Lane Cove Council

Development Application: DA35/2024 – Demolition, Excavation and Construction of a Residential Flat Building Development.
Property: 1 Gatacre Avenue & 1-5 Allison Avenue Lane Cove.

I refer to the above Development Application. This letter is to advise that a preliminary review of the application has been undertaken and to outline a request for further information under Clause 54 of the Environmental Planning and Assessment Regulations 2000.

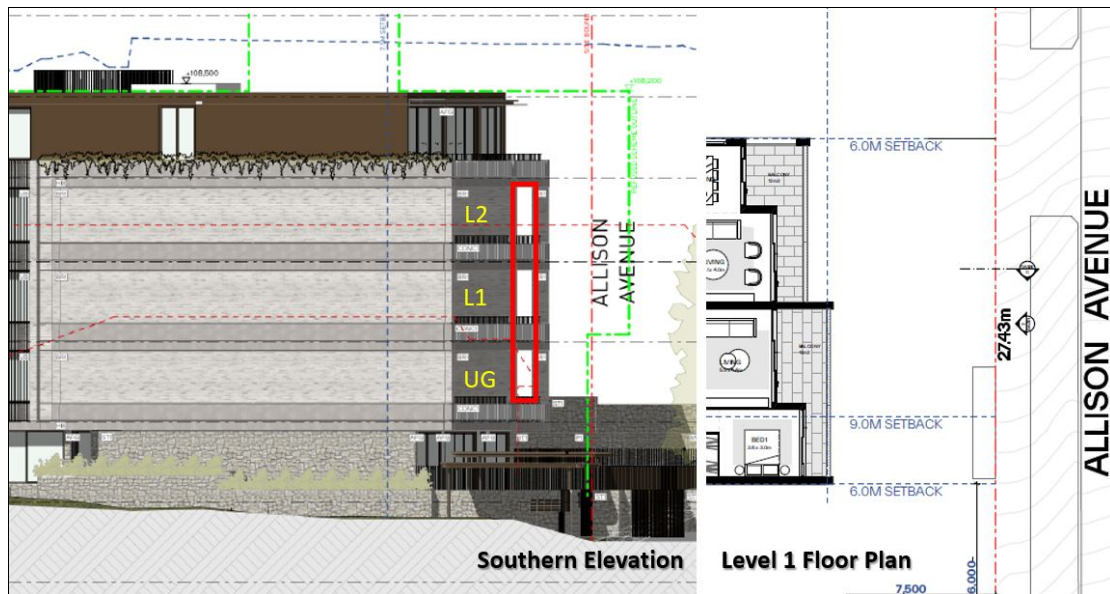
3. Openings on south elevation towards 7 Alison

The southern elevation plan (DA200) appears to show openings on the front balconies on upper ground, level 1 and level 2 facing 7 Alison Avenue. See red outline notation on elevation below, and Level 1 plan which has no associated openings on the south facing wall. Given that the building setbacks from this boundary are at 6m, this wall should be non-habitable and feature no windows/openings.

Figure 3: Dimensions used for SRV in TTPA traffic and parking report.

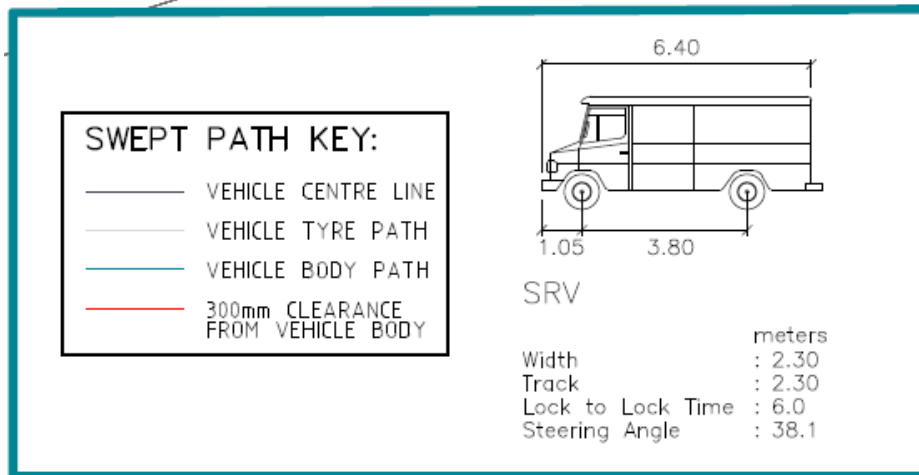
compliant 6.64m length x 2.37m width design vehicle (see Figures 3 and 4 below).

Figure 5: Traffic signal adjacent to driveway.

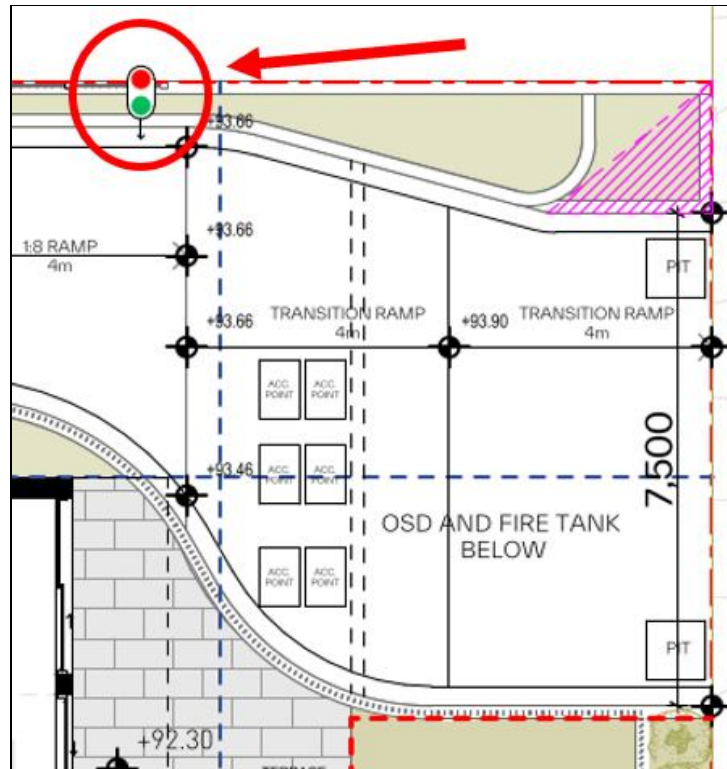
- (iv) The documentation has not shown vertical clearance height of basement levels. Noting that the height of the Council refuse vehicle is 2.6m. AS 2890.2:2018 requires a minimum clearance height for SRV to be 3.5m. Please provide longitudinal sections of ramps to confirm they meet AS requirements.
- (v) The doors in the basement 1 floor “BULKY WASTE ROOM” and “WASTE ROOM” open outwards towards the path of travelling vehicles. This may lead to potential conflicts. The doors should be redesigned to open inwards or be sliding doors.
- (vi) The architectural plan shows traffic signals at the ground floor vehicle entrance. (See figure 5 below) There is no information in the TTPA report if traffic signal is for pedestrians or vehicles. Please provide further information given that the driveway width is 7.5m for pedestrians to cross.
